Report: TAB Report
Function: Test, Adjust, & Balance
Date: 03/28/2025
Completed By: National TAB

Springer School Addition (Cincinnati, OH)

Project: Springer School Addition (Cincinnati, OH)

Project Issue Information

M101

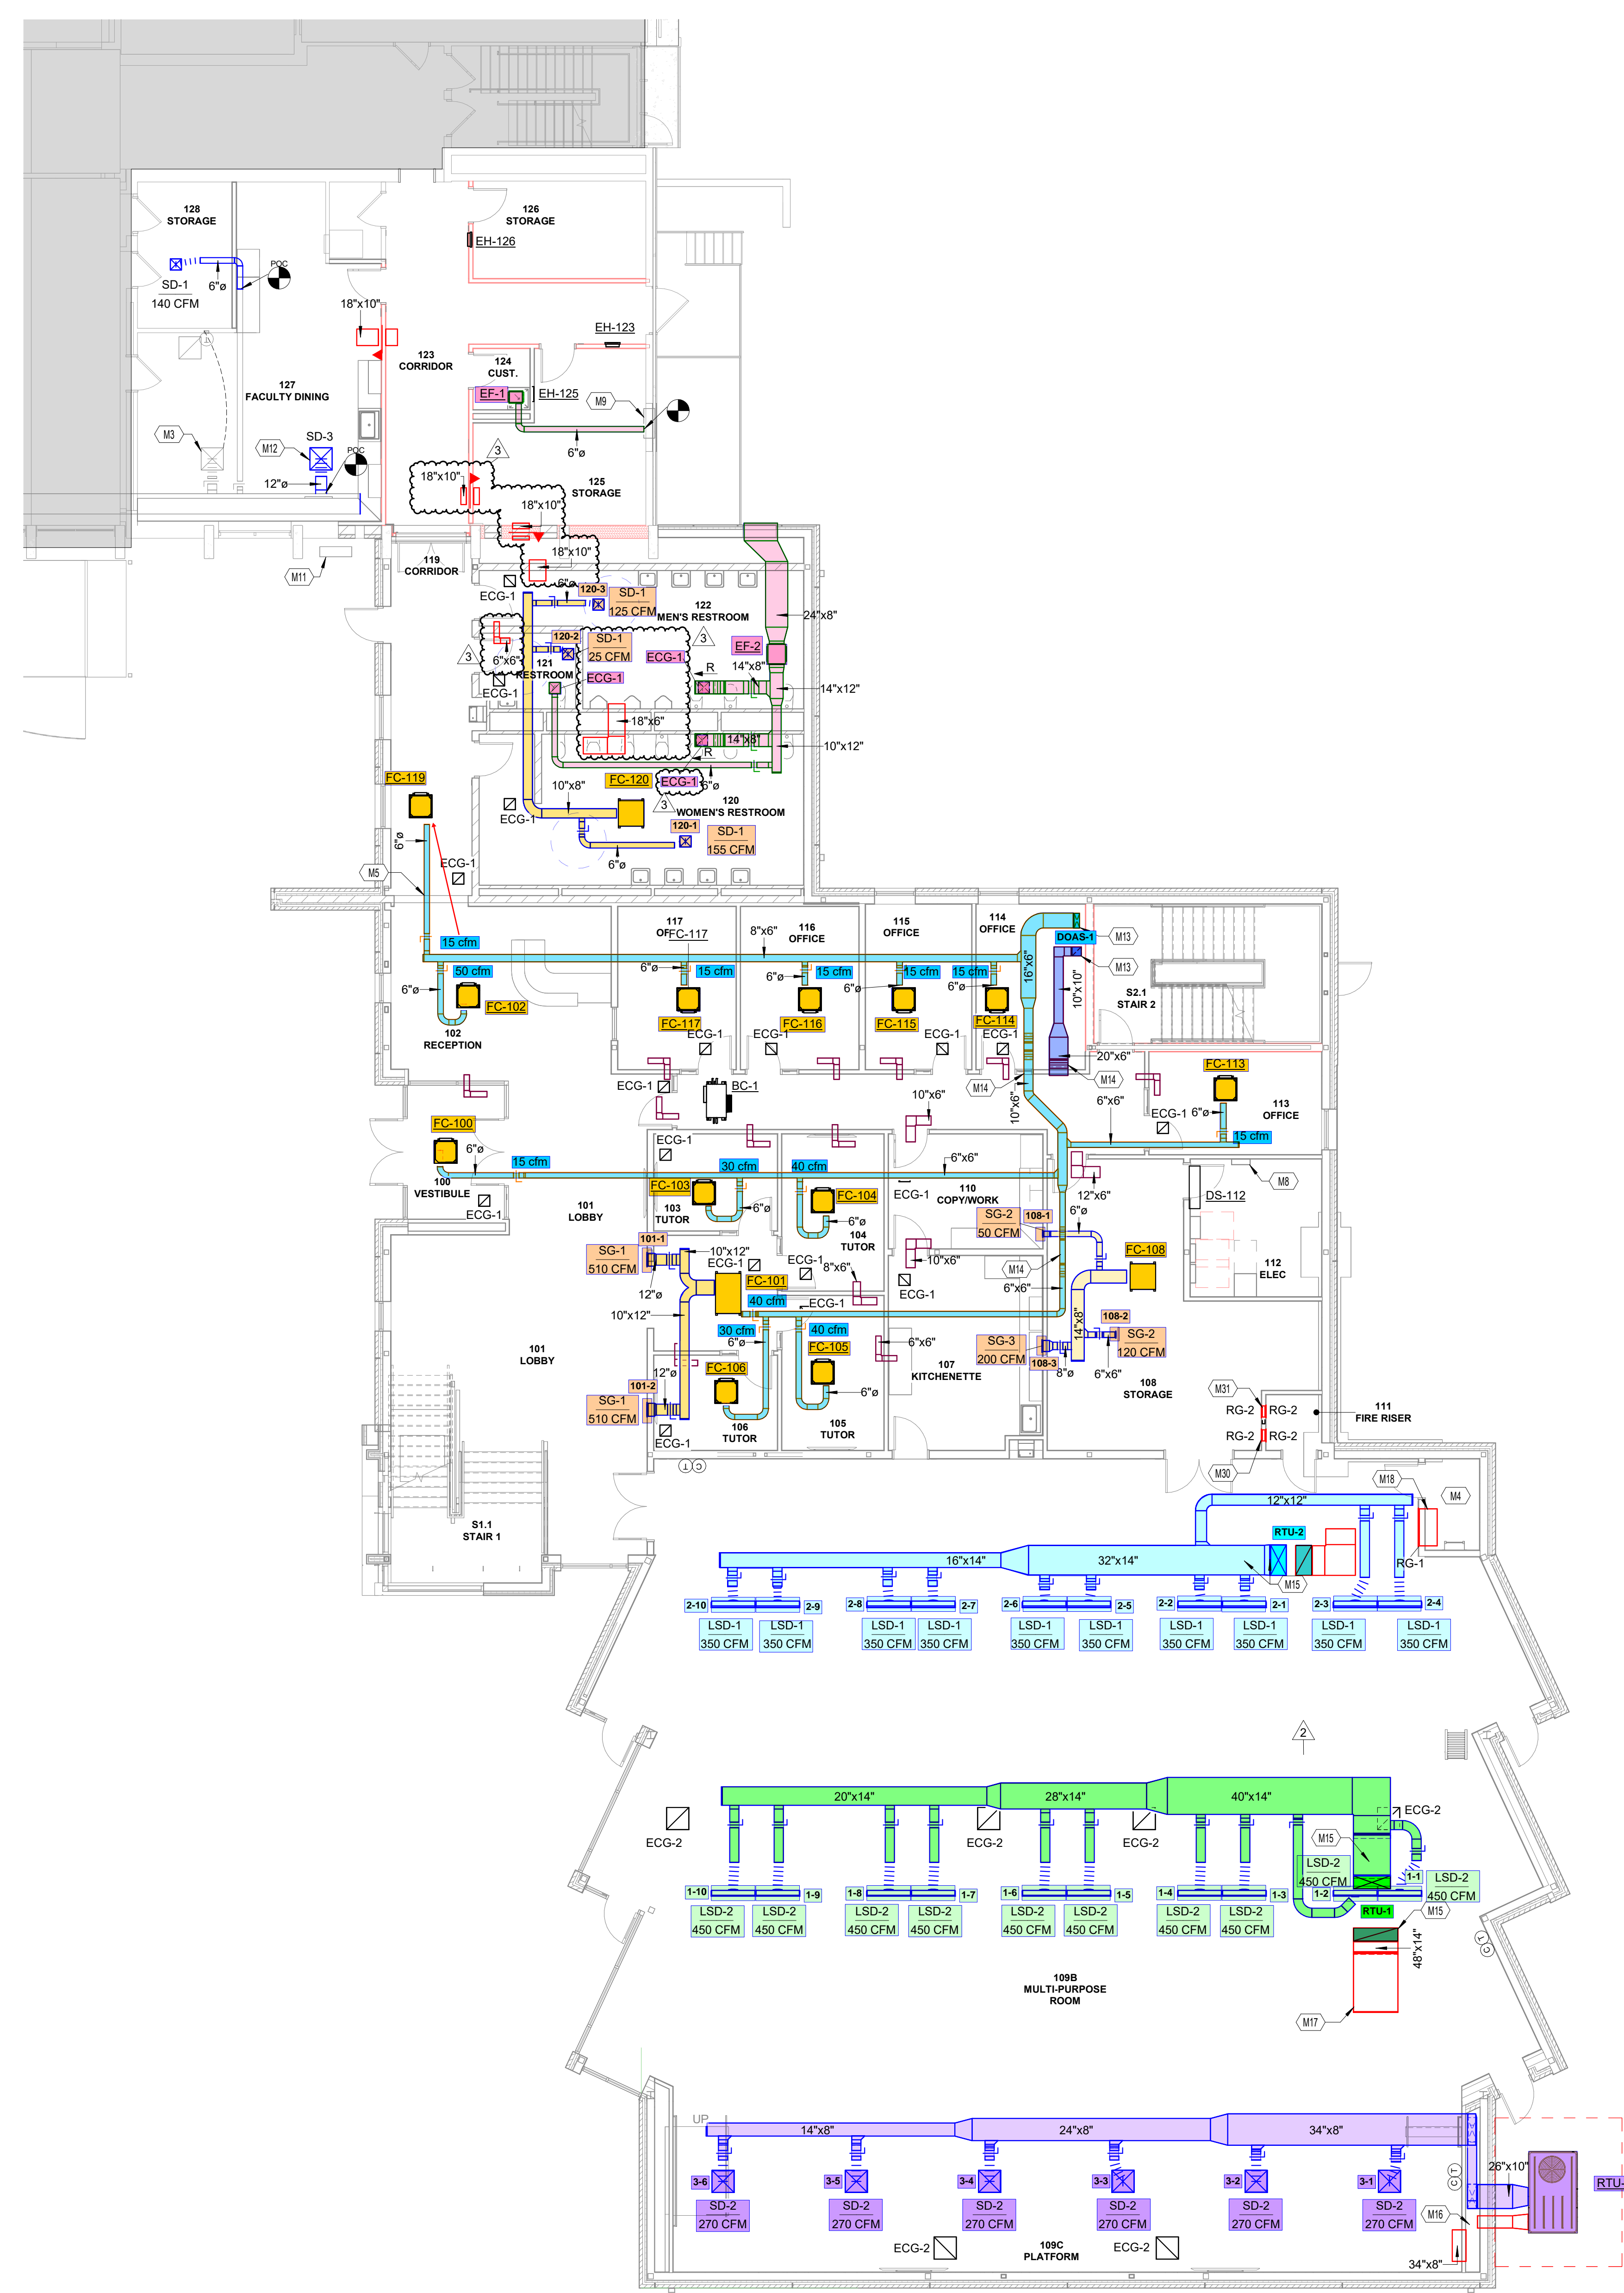
Issue Name : RTU-3 VFD Appears Non-Functional
Description : VFD for RTU-3 does not appear to be functional. When fan is running, VFD displays all 0's. Unit was read out in test mode. Suspect incomplete startup by Trane or malfunctioning VFD. Recommend contacting Trane to further investigate.

12/20/2024
